CONTRACT CHANGE ORDER NO. _____
 SHEET _____ OF _____

UNDERGROUND DUCT BANKS AND MANHOLES
 SCALE: 1:200

E-11A

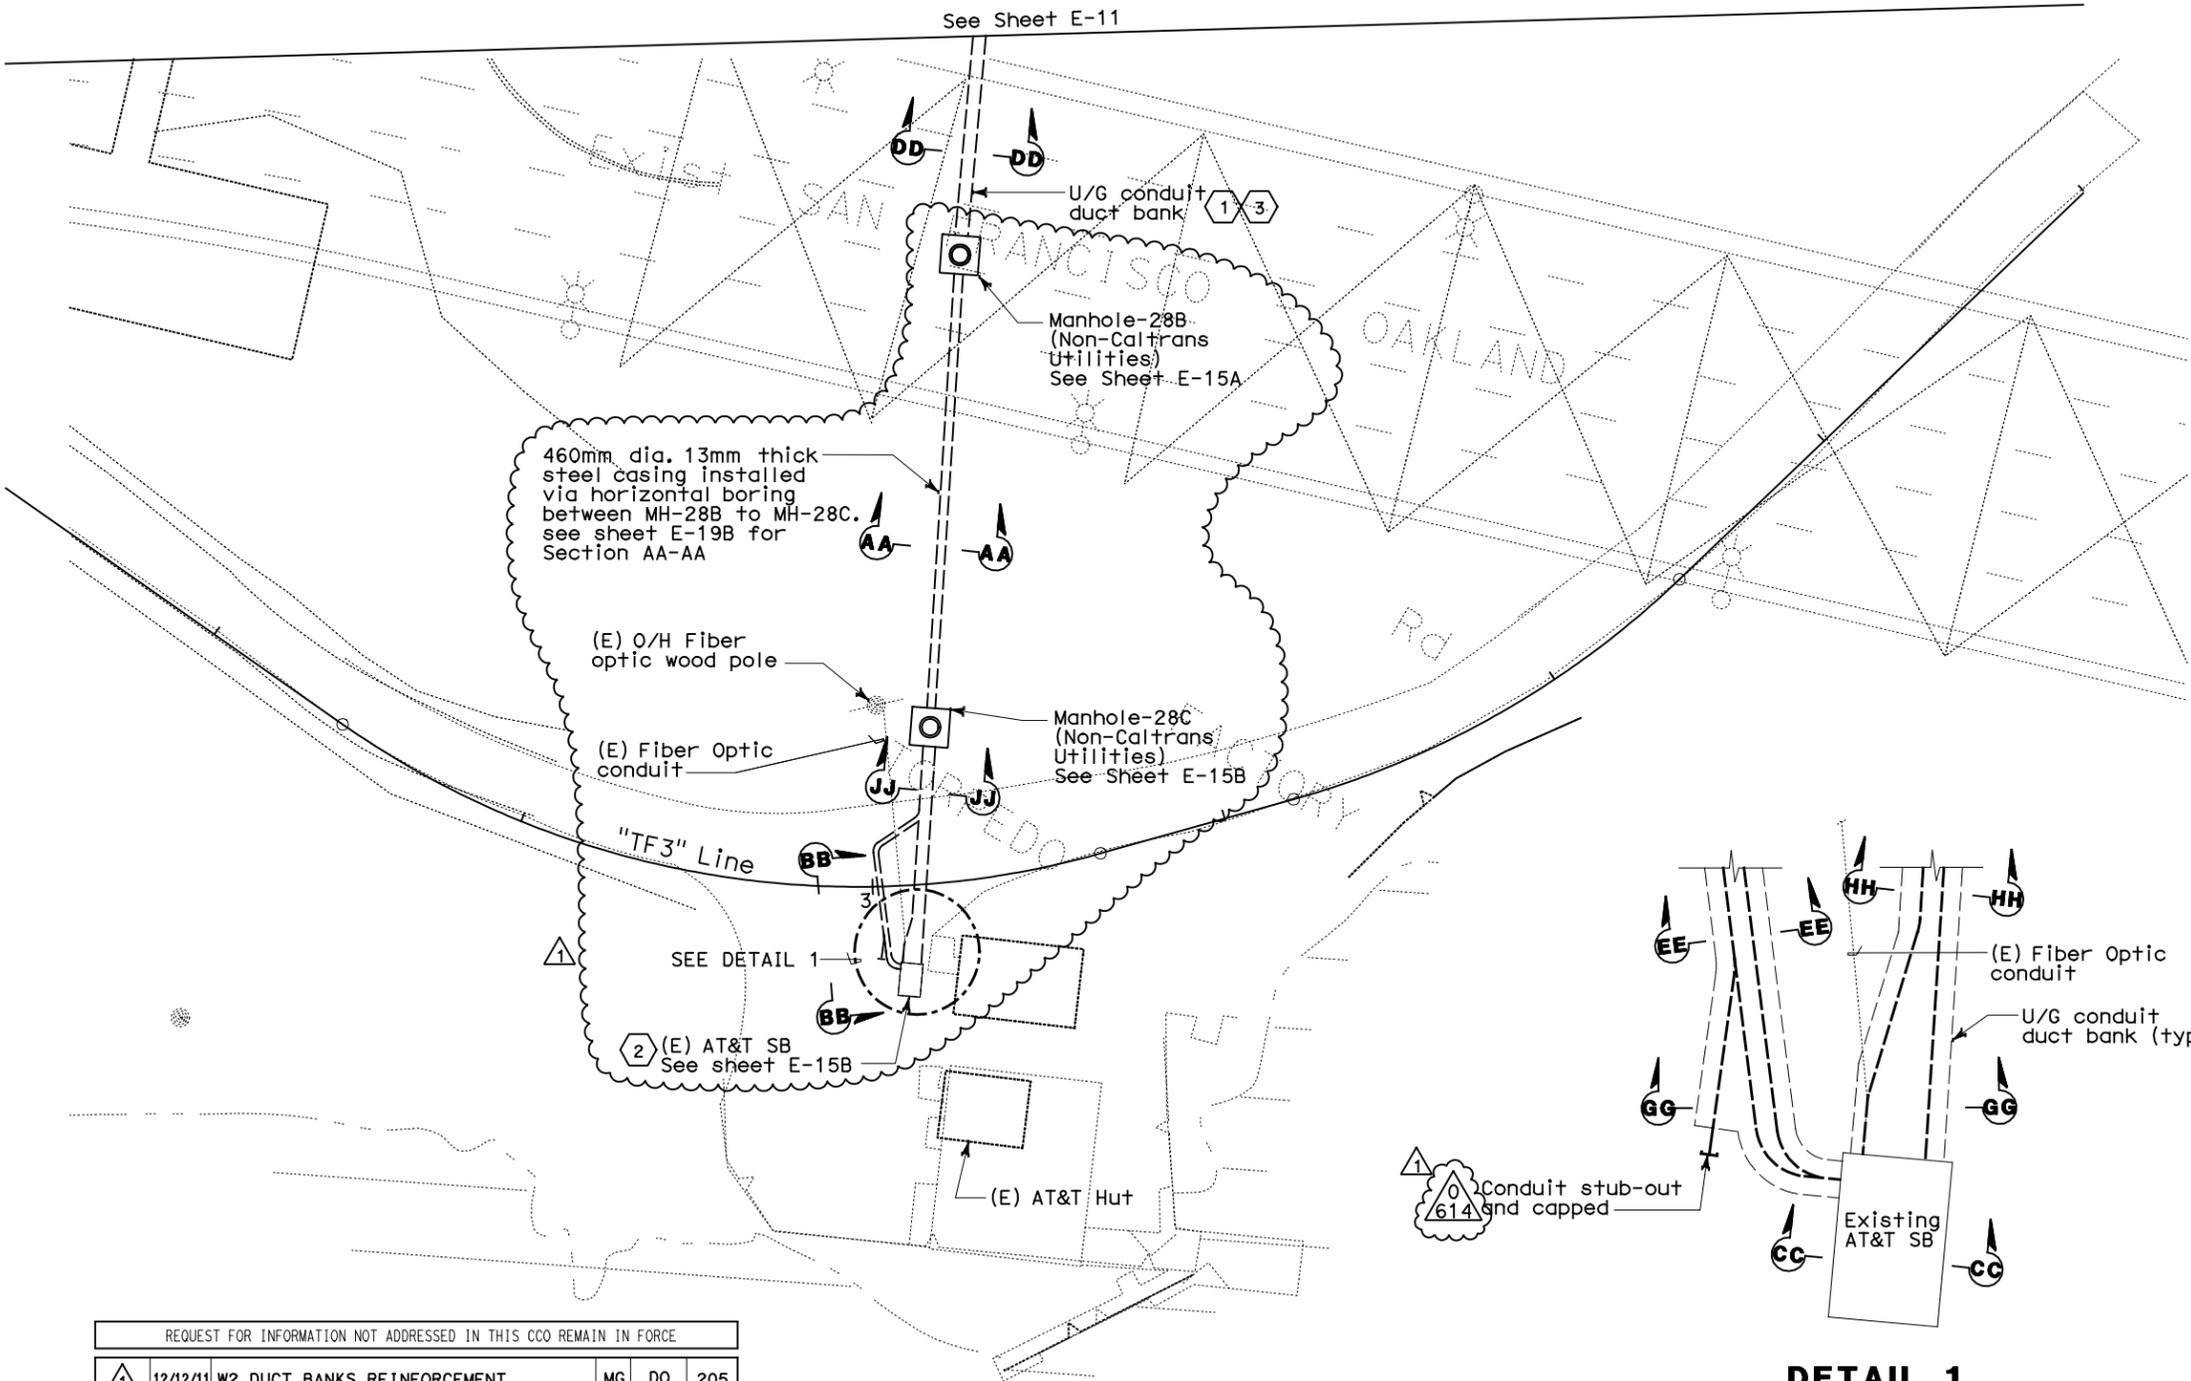
REQUEST FOR INFORMATION NOT ADDRESSED IN THIS CCO REMAIN IN FORCE					
△	12/12/11	W2 DUCT BANKS REINFORCEMENT	MG	DO	205
△	08/08/11	W2 DUCT BANKS REINFORCEMENT	EJL	RG	205
MARK	DATE	DESCRIPTIONS	BY	CH'D	CCO#
REVISIONS
